PROJECT TECHNICAL MEMORANDUM

JOB TITLE : Manchester City College
PROJECT NO : 28161
DATE : 26 May 2021
FROM : Tom Bonnert
ISSUED TO : Briggs & Forrester

RE: MANCHESTER CITY COLLEGE PLANT NOISE EGRESS

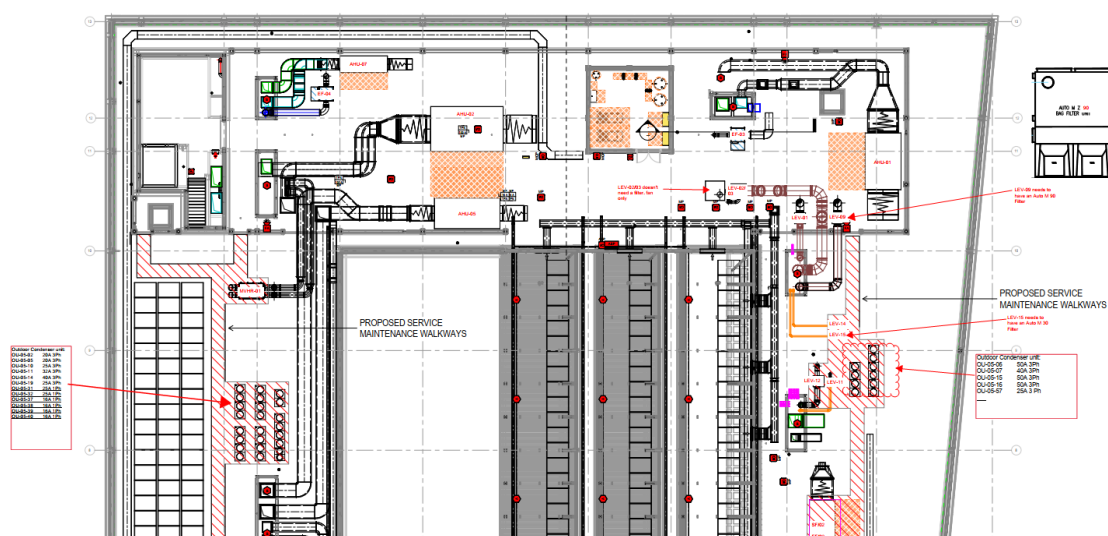
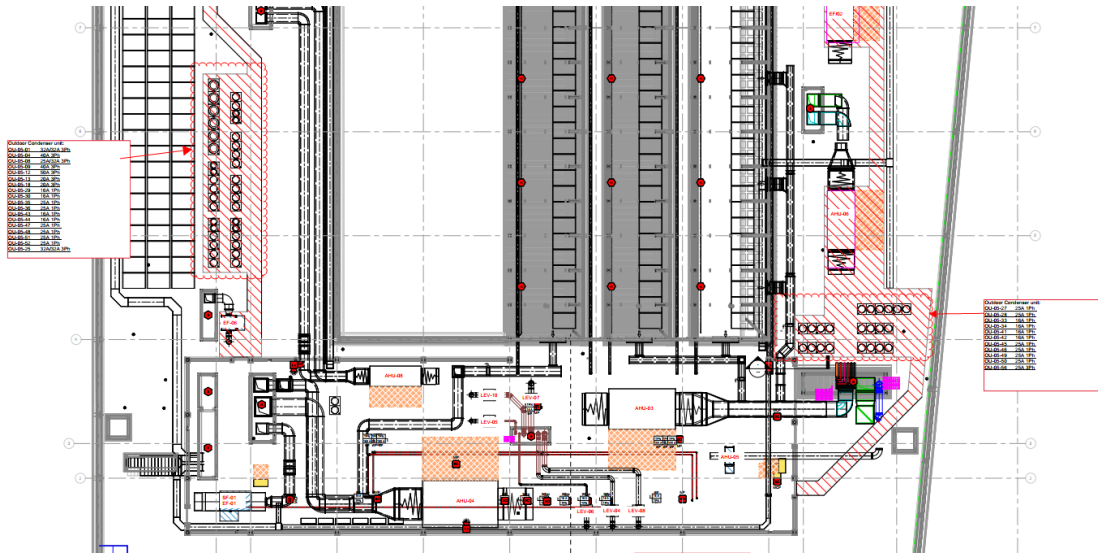
Screenshots of the mechanical services drawings are included in the following figures.

It should be noted that following ongoing design discussions the condensers have been relocated since receipt of the above plant location drawing, and our revised assessment as presented herein is based on the condenser locations indicated on the following drawings:

- CC-BAF-ZZ-RF-DR-M-5520_C01 - Roof Level - VRF & Split Systems Layout Sheet 1 of 4
- CC-BAF-ZZ-RF-DR-M-5521_C01 - Roof Level - VRF & Split Systems Layout Sheet 2 of 4
- CC-BAF-ZZ-RF-DR-M-5522_C01 - Roof Level - VRF & Split Systems Layout Sheet 3 of 4
- CC-BAF-ZZ-RF-DR-M-5523_C01 - Roof Level - VRF & Split Systems Layout Sheet 4 of 4
